Summary Reviews of Select Aspects of the USEPA Upper Hudson River Models

**Presented to the USEPA Baseline Modeling Report Peer Review Members
March 27, 2000**

**Quantitative Environmental Analysis, LLC
Montvale, NJ 07645**

Figure 1. Numerical simulation of erosion in EPA sediment model.

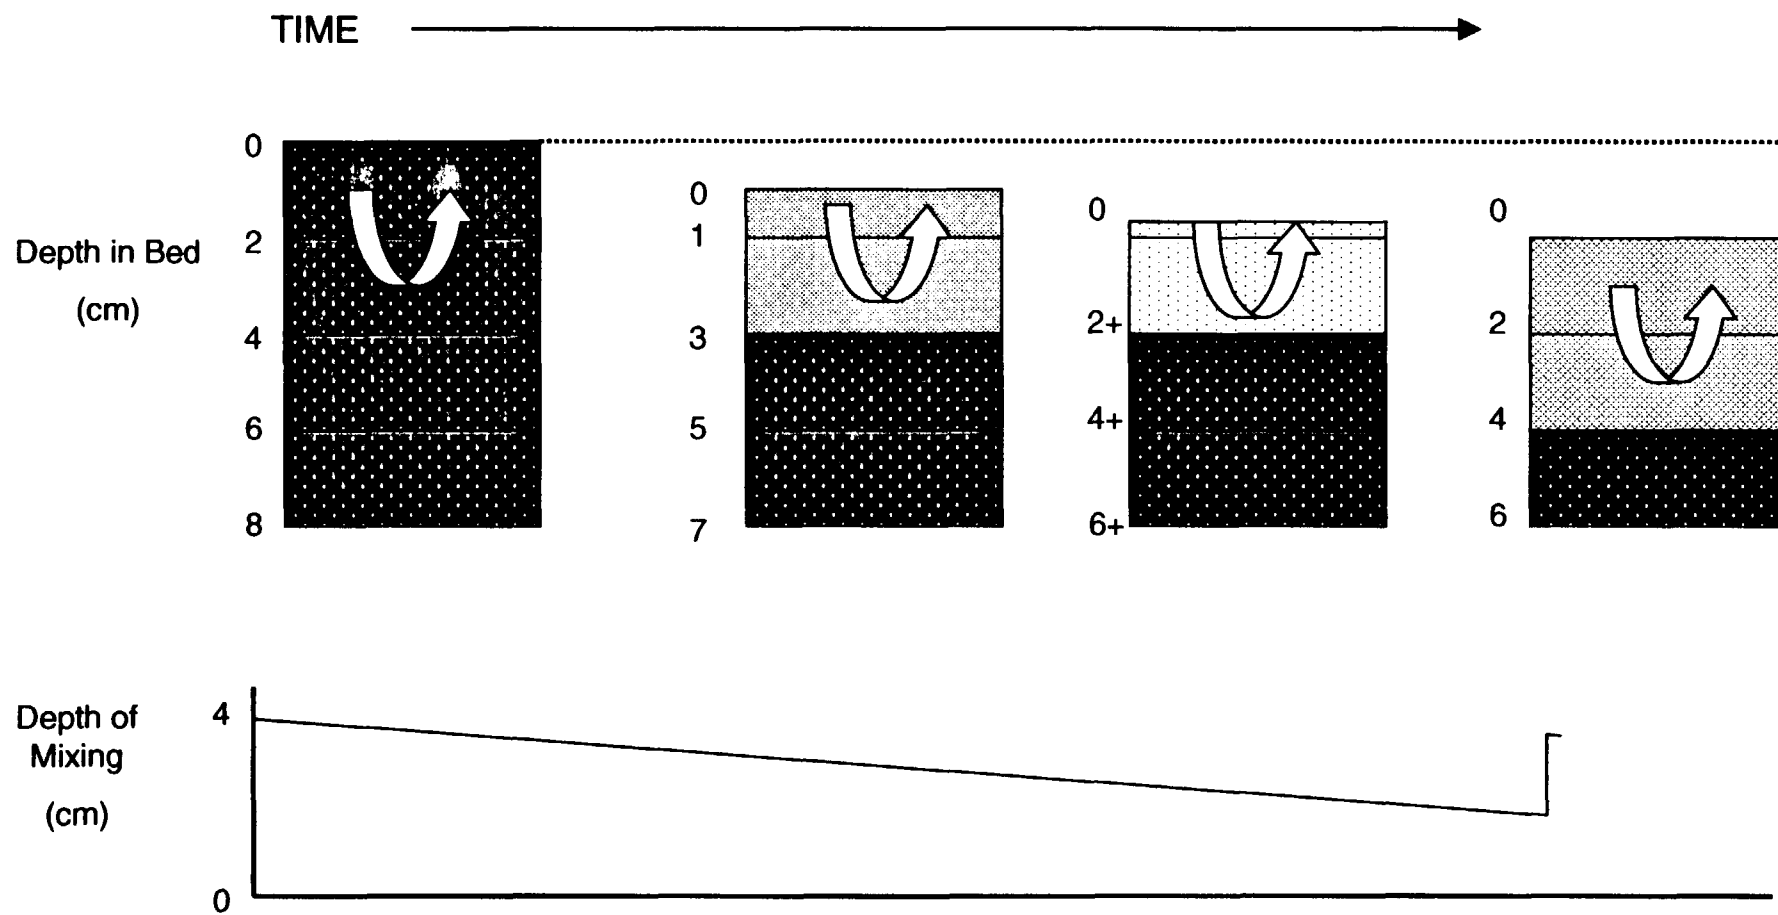
The numerical artifact of declining and then instantaneously increasing the depth of the surface mixed layer is exacerbated by the manner in which the model results are presented. The predicted concentrations in Figures 8-4, (a-e) **do not** represent the top 0-4 cm of sediment as stated in Section 8.3. Instead, they represent an average of the top two sediment segments. Because the depth of the topmost layer changes, the depth of sediment represented in the figures changes also. The presented results in an area of net erosion track a progressively thinner layer of surface sediment (i.e., from 4 to 2 cm) and then instantly a thicker layer (i.e., 4 cm) that again becomes progressively thinner.

Evidence that the predicted increases are due to the model's numerical procedures rather than a real phenomenon can be obtained by examining how the predicted increases change as the resolution of the numerical grid is changed. QEA ran it's bed model using EPA's parameters for particle mass transfer, net erosion, and molecular mass transfer as well as a mixing depth of 4 cm as was used in the Stillwater Reach. The model was run with a segment thickness of 2 cm as well as 0.2 cm to demonstrate that the apparent increase is easily reproducible and a function of layer thickness. We were able to reproduce the sudden increase when using 2 cm layers (Figure 2). As the sediment model

Figure 2. Illustration of error in EPA sediment model.

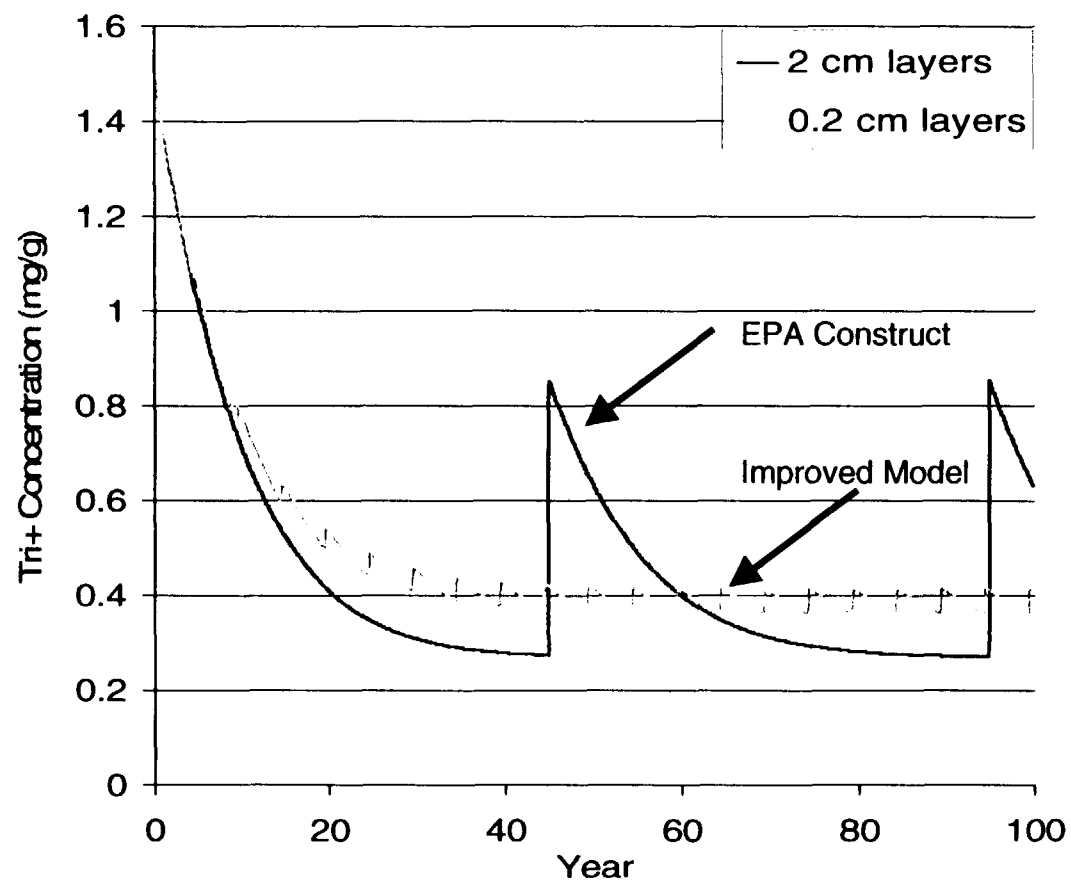
segmentation was refined, the sharp increases due to this numerical artifact began to disappear. As shown in Figure 2, use of segments 0.2 cm thick results in near complete elimination of the increases.

Figure 1. Comparison of USGS and GE solids load sampling methods.

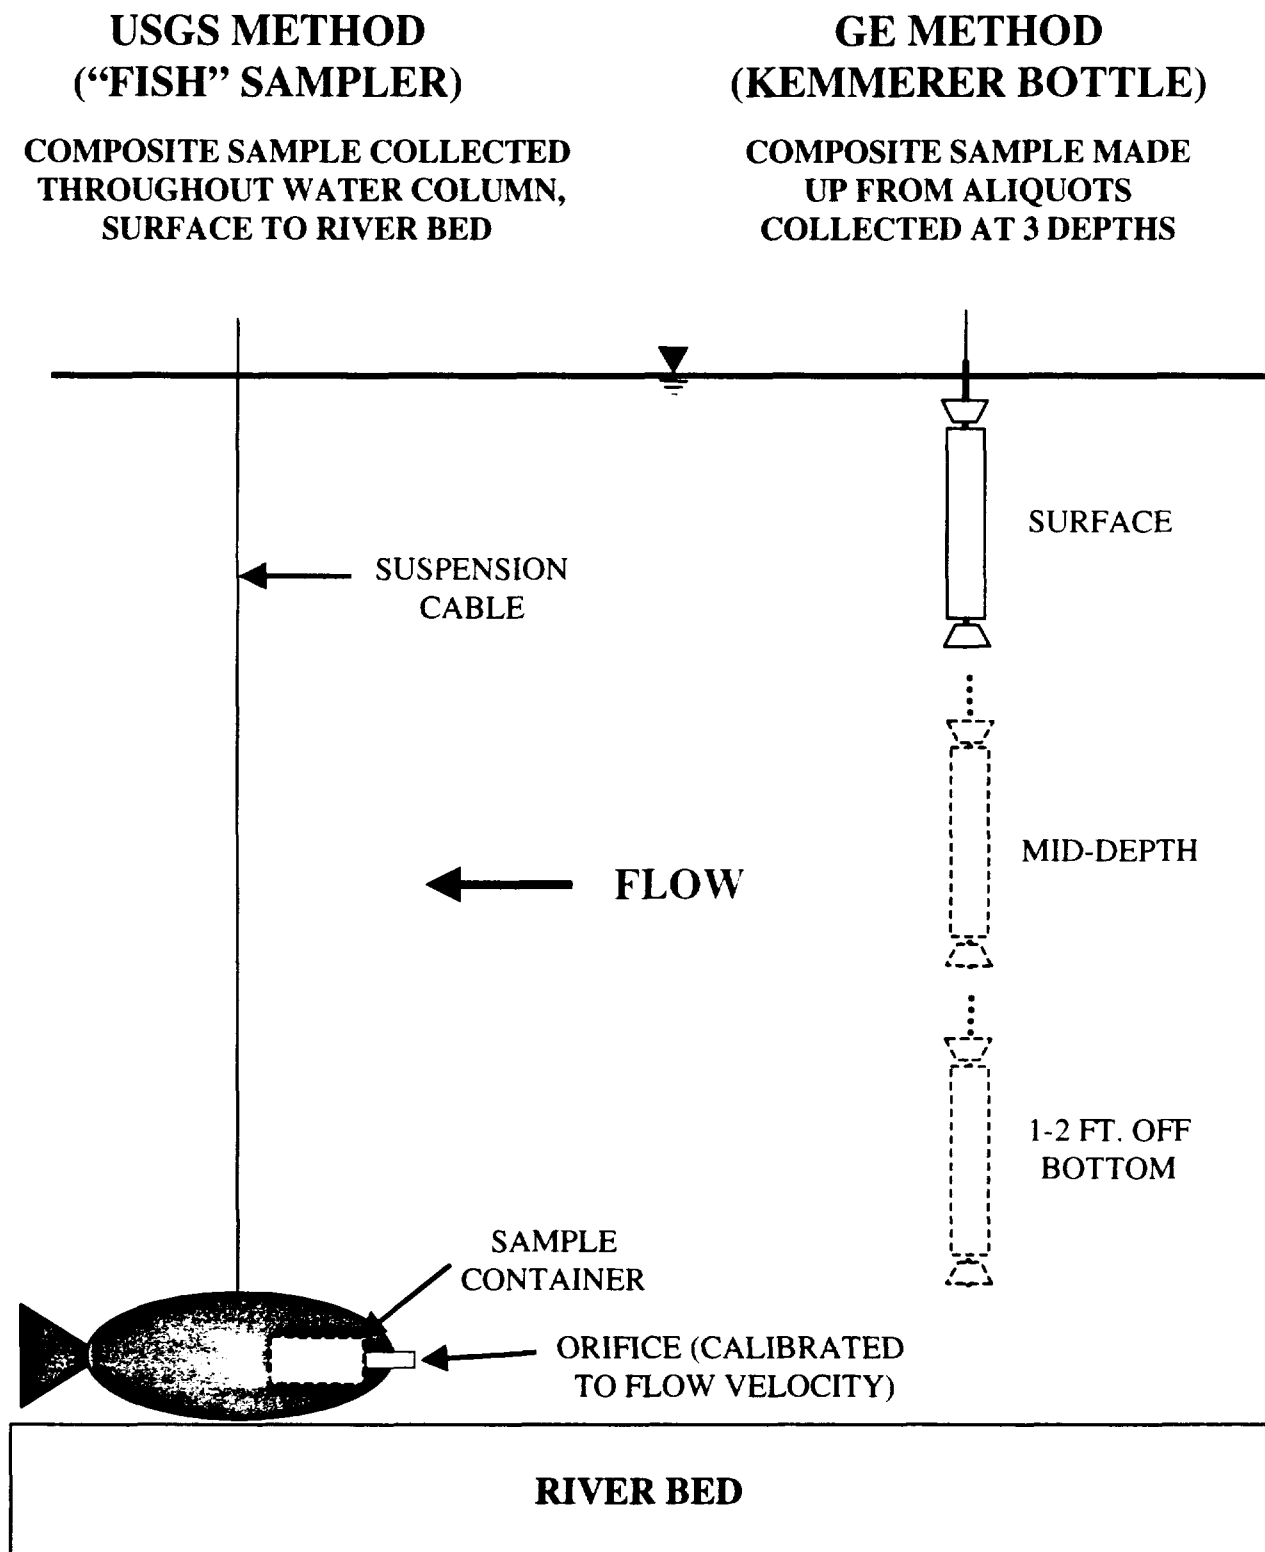
There are two reasons that support the use of the USGS data to estimate solids loadings. First, the USGS methodology is specifically designed to measure sediment loads, whereas GE's methodology is not. GE samples are taken at three locations in the water column: 0.2, 0.5 and 0.8 times the depth (e.g., in 2 m of water, the bottom GE sample

would be 40 cm above the sediment bed). The USGS method, in contrast, utilizes a sampler that samples continuously throughout the water column, from the surface to within 6 cm of the sediment bed. Thus, the GE method does not produce a vertically-averaged TSS concentration that adequately samples near-bed sediments, where a major fraction of the suspended sand load is located. In addition, the USGS sampler is a flow-through device that is specifically designed for sampling suspended sediment. A Kemmerer sampler is used by GE to collect TSS samples. The design of this device is such that suspended sands, with relatively high settling speeds, may not be adequately sampled. Second, the USGS methodology has remained constant throughout the relevant period (i.e., 1977 to the present), whereas GE's different methodology was introduced in 1990. It is far preferable to use a consistent data set than to rely on data from two different methodologies. Thus, it is appropriate to rely primarily on the USGS data set to establish solids loading over time at Fort Edward.

Figure 2. Estimated solids loading at Ft . Edward for post-1990 (1991-1998) period using various rating curves. Error bars represent the 95 % confidence interval.

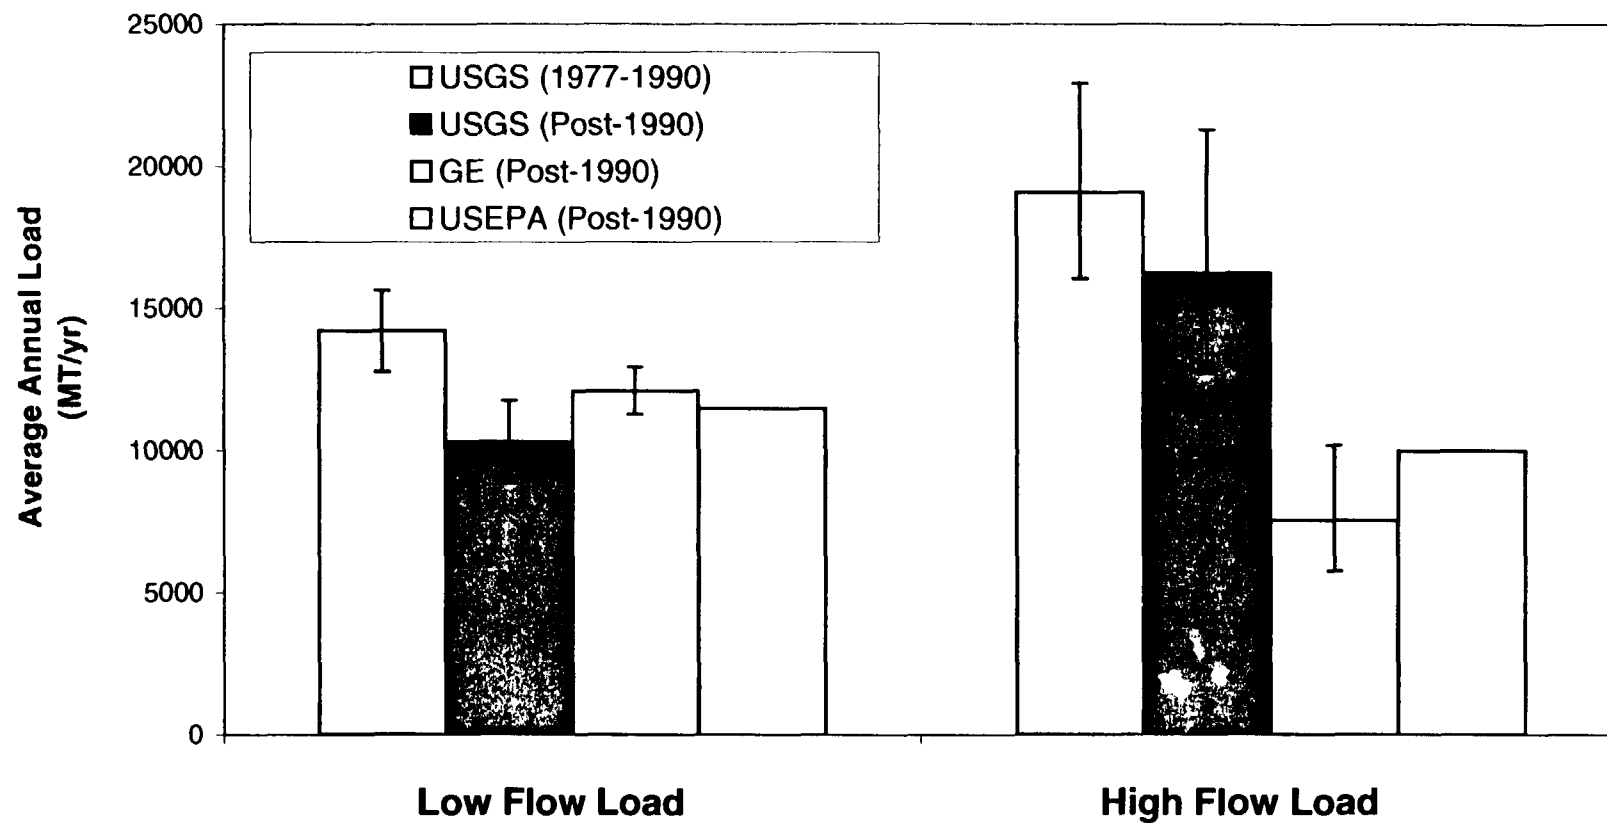
A more robust test of the loading-change hypothesis involves comparison of 1977-90 and post-1990 solids rating curves developed from the USGS data. This comparison is critical because, ultimately, rating curves are used to calculate solids loading. Two different methods were used to compare these two rating curves. First, the average annual solids loading for the post-1990 period (1991-1998) was calculated using both rating curves (Figure 2). This approach eliminates any potential effects due to hydrograph variations. The resulting loading rates were 33,300 and 26,600 MT/yr for the 1977-90 and post-1990 rating curves, respectively. Thus, the post-1990 rating curve yields an average annual load that is 20% lower than the 1977-90 rating curve. A large fraction of that difference is attributable to low-flow conditions (post-1990 is 28% lower), whereas the post-1990 high-flow load is only 15% lower than the 1977-90 loading. Second, the two high-flow rating curves were statistically compared and were not significantly different at a 95% confidence level. For the low-flow regime, minimal correlation existed between TSS concentration and flow rate, so, consistent with USEPA's approach, mean values were determined for each period. It was determined that the average low-flow TSS concentrations were statistically different, but the difference was not large, with mean values of 4 and 3 mg/l for the 1977-90 and post-1990 periods, respectively. Therefore, differences exist between the 1977-90 and post-1990 periods in Fort Edward solids loading; statistically significant differences occur under low-flow conditions, with relatively small differences observed during high-flow conditions. It should be noted that high-flow solids loading has a much larger impact on sedimentation than sediment loads brought in during low-flow periods, i.e., episodic deposition occurs in the UHR with most of the annual sedimentation occurring during relatively rare high-flow events. Thus, proper analysis of the USGS data shows that the solids loading during high flow at Fort Edward did not decline after 1990, and only a small drop in solids loading occurred during low flow after 1990.

It appears that USEPA's hypothesized reduction in solids loading after 1990 is due to the Agency's reliance on the GE data, as illustrated by comparing the USGS post-1990 rating curve with the GE post-1990 rating curve. Comparing the two data sets in this manner is crucial because: 1) all of the data are used, not just a limited number of paired measurements and 2) differences in solids loading estimates can be quantified. Large differences between the resulting rating curves, particularly in the high-flow regime, are evident in Figure 3. These rating curves were used to calculate Fort Edward solids loading for an eight-year period, from January 1, 1991 to December 31, 1998 (Figure 2). The rating curve developed from the GE data produced a total solids load for this period that was 24% lower than the USGS rating curve overall, with a much larger difference during high-flow periods (54% lower) than during low-flow periods (17% higher). The apparent low-bias of the GE TSS concentration data during high-flow conditions probably results from the configuration of the sampling device and the sampling procedure, as described previously (Figure 1). Thus, the GE TSS concentration data should not be used for calculating total suspended solids loading at Fort Edward.

Figure 1. USEPA (specified) and GE (calculated) relationships between effective settling speed and flow rate for the cohesive bed in the TIP.

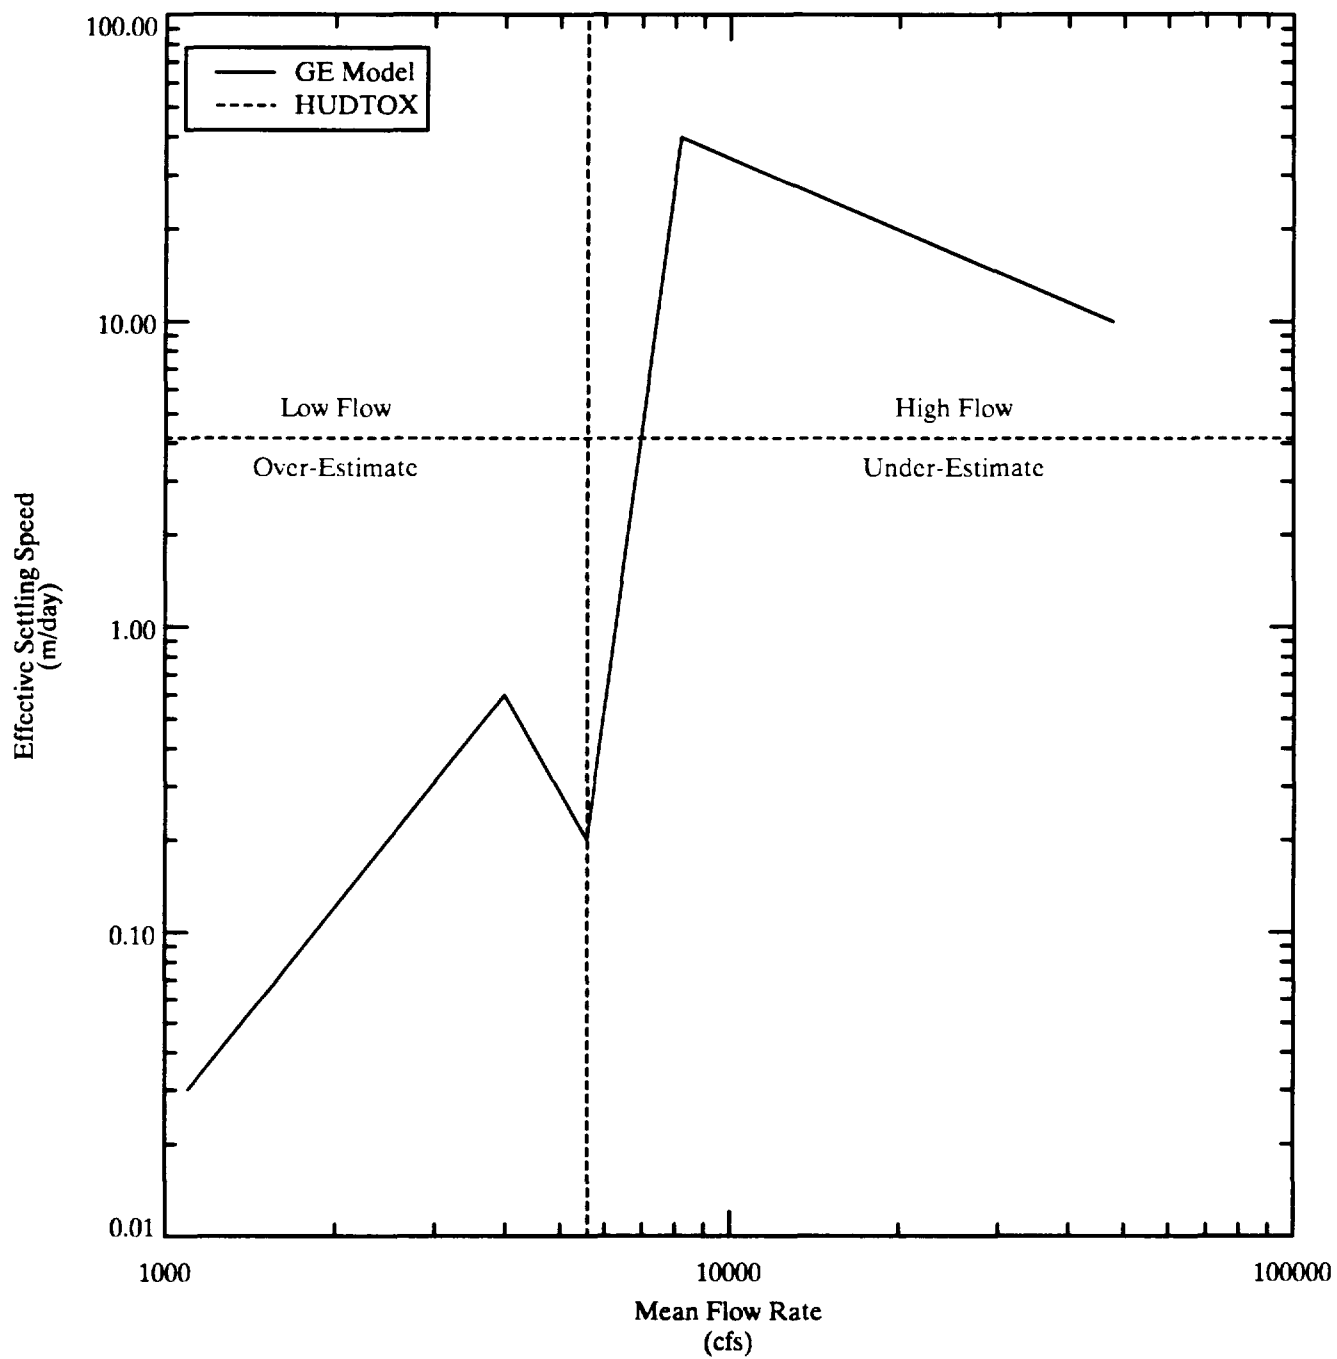
Similar deposition formulations were applied to cohesive and non-cohesive bed areas in HUDTOX. Effective settling speeds used in HUDTOX were temporally constant and spatially variable, with a higher value in cohesive areas than in non-cohesive areas. This approach overlooked three important phenomena that affect deposition: 1) variable bottom shear stress or, equivalently, flow rate (i.e., probability of deposition effects); 2) changes in composition of water column solids (i.e., relative amounts of clay, silt and sand in suspension); and 3) flocculation of clay and silt particles. An example of these effects on effective settling speed is illustrated in Figure 1, which shows results from the GE sediment transport model (a mechanistic model that USEPA has accepted) for a cohesive bed area in the TIP (QEA 1999). The effective settling speed relationship shown on Figure 1 is typical for the UHR, with relatively low settling speeds during low-flow conditions due to most of the suspended load being composed of flocculating clay and silt particles. During high-flows, significant increases in suspended sand content occur, causing the effective settling speed to increase by more than an order of magnitude. Even though the HUDTOX effective settling speed for cohesive bed areas (4.15 m/day) may approximate a long-term average value, it is too high during low-flow and too low during high-flow (Figure 1).
